Addendum - As Built Changes

PROJECT ADDRESS: 726 CAROLINA AVE
REQUEST TO ADD ADDITIOINAL 110 SQ FT OF LOFT SPACE AND EXTERIOR 2ND FLOOR BALCONY
LOFT OCCUPIES SPACE IN EXISTING FRONT 2-STORY FRONT ENTRY

DATE
					REVISIONS
					BY
					NO.
GOLDWORTH RESIDENCE 726 CAROLINA AVE. SUNNYVALE, CA					
PHILIP GOLDWORTH OWNER/BUILDER					
DATE: 8/11/2016					
SCALE:					
DRAWN:					
JOB:					
SHEET					
Project Data

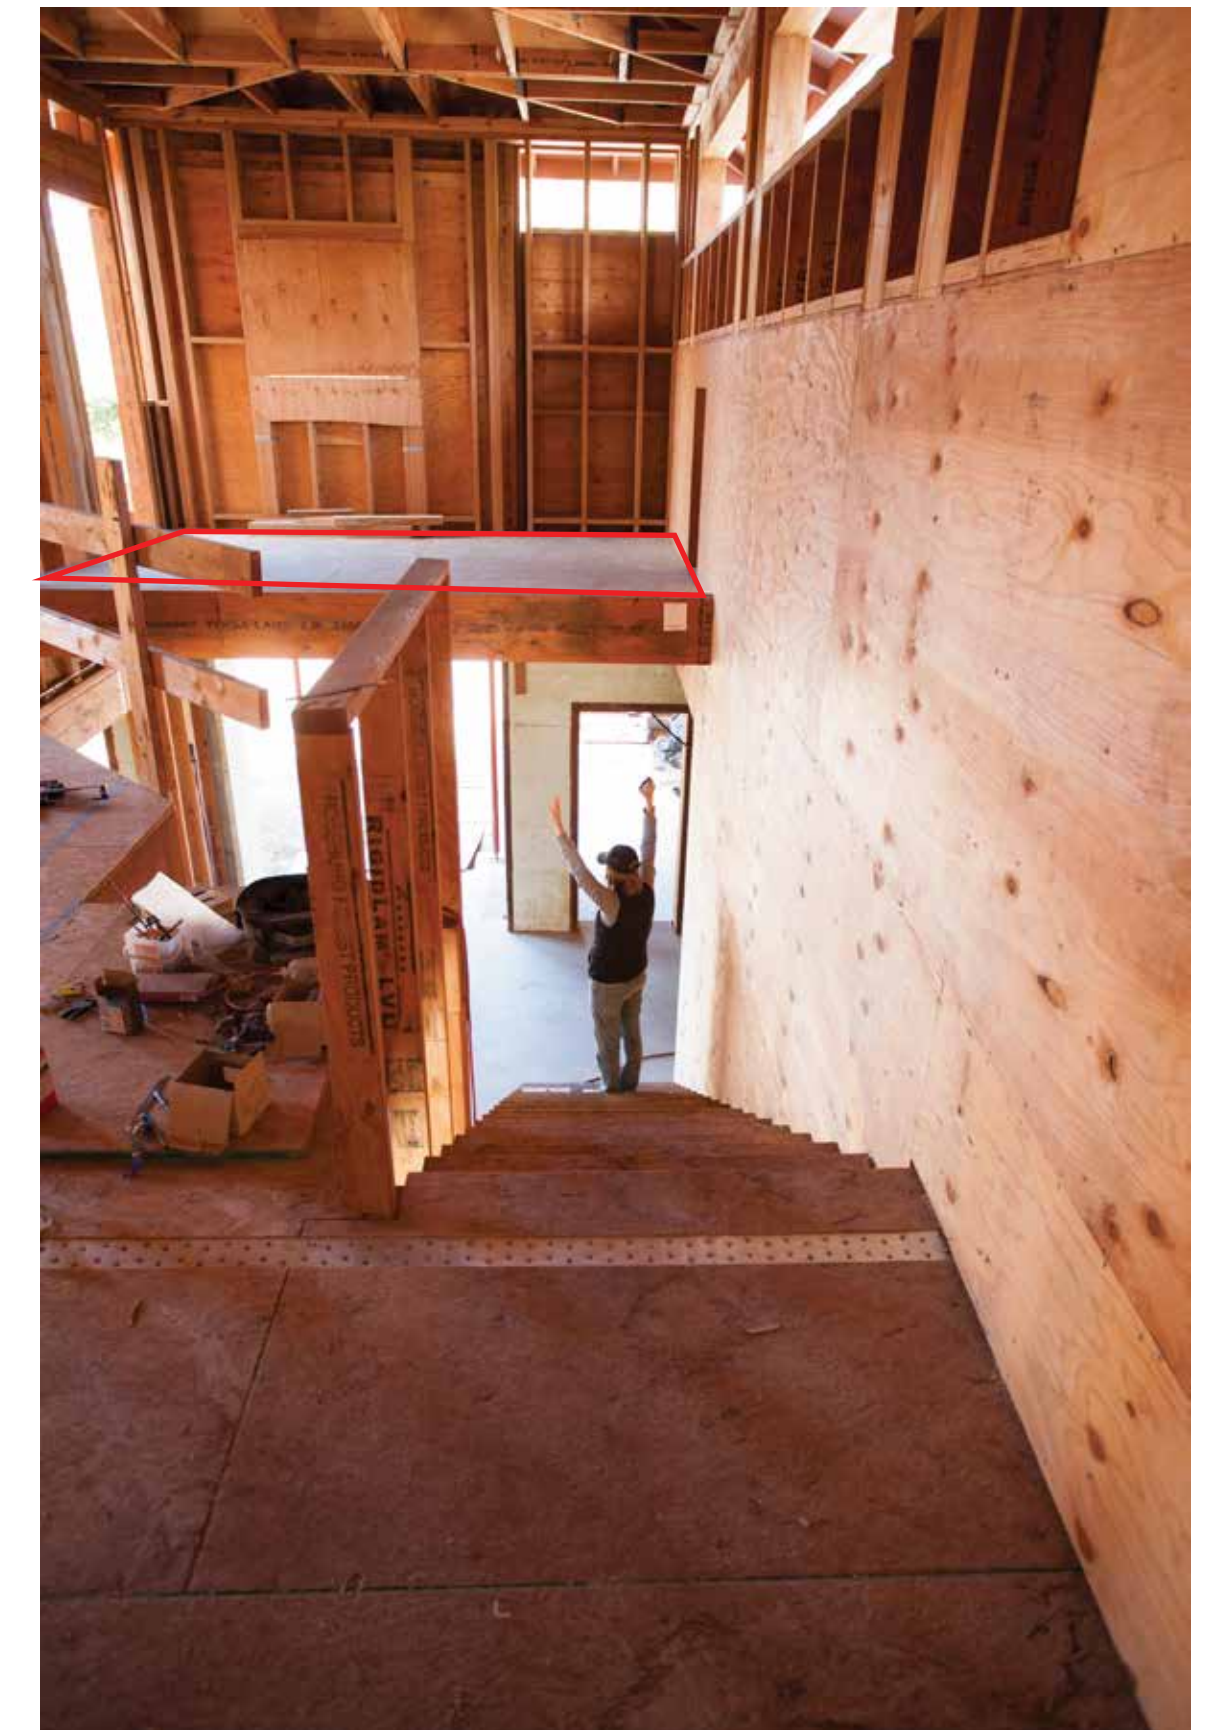
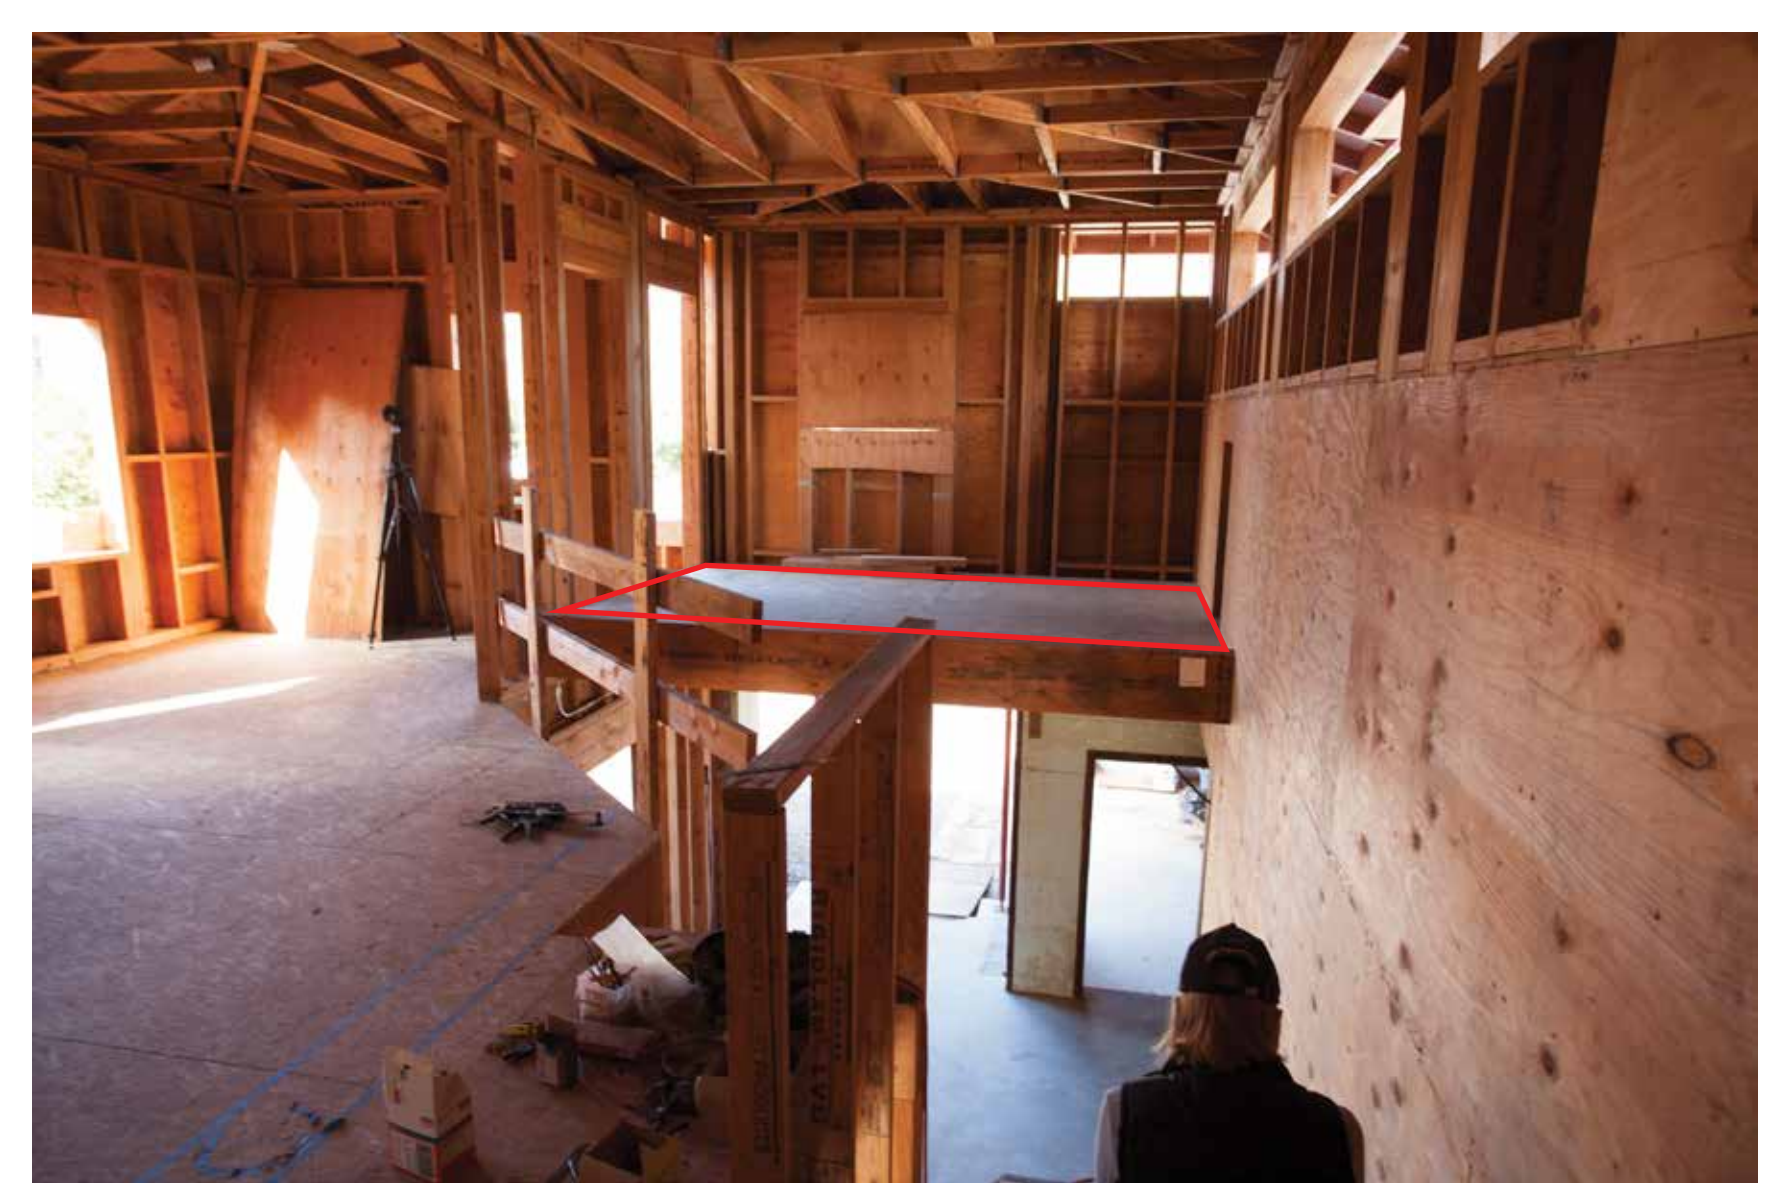
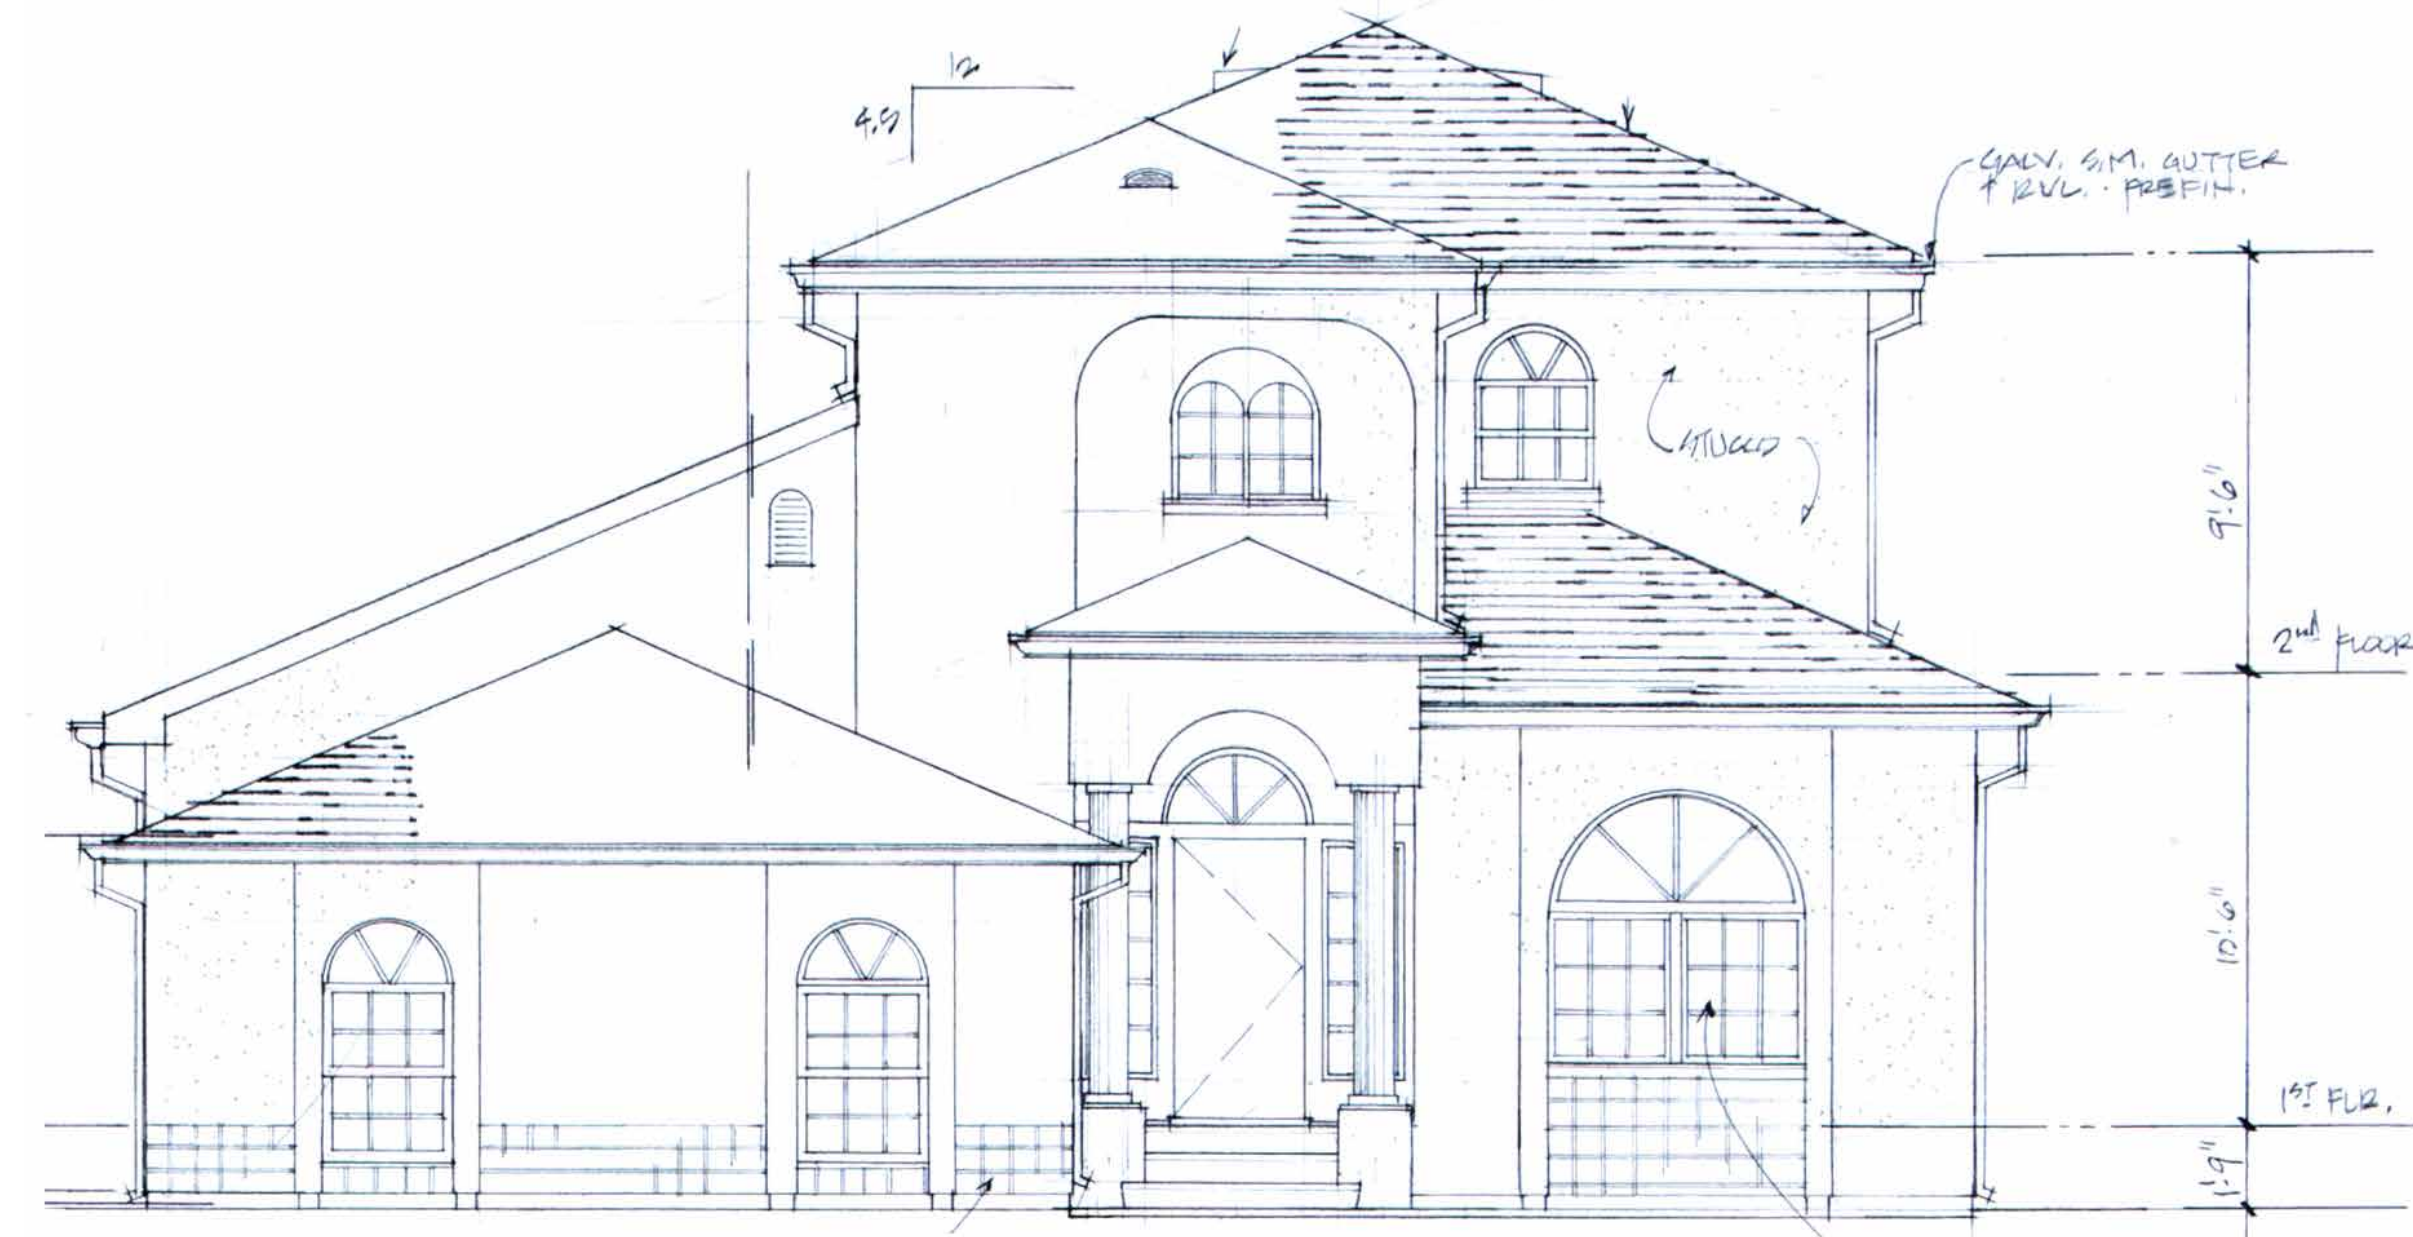
NEW VIEW FROM BALCONY

NEW LOFT AND BALCONY ACCESS
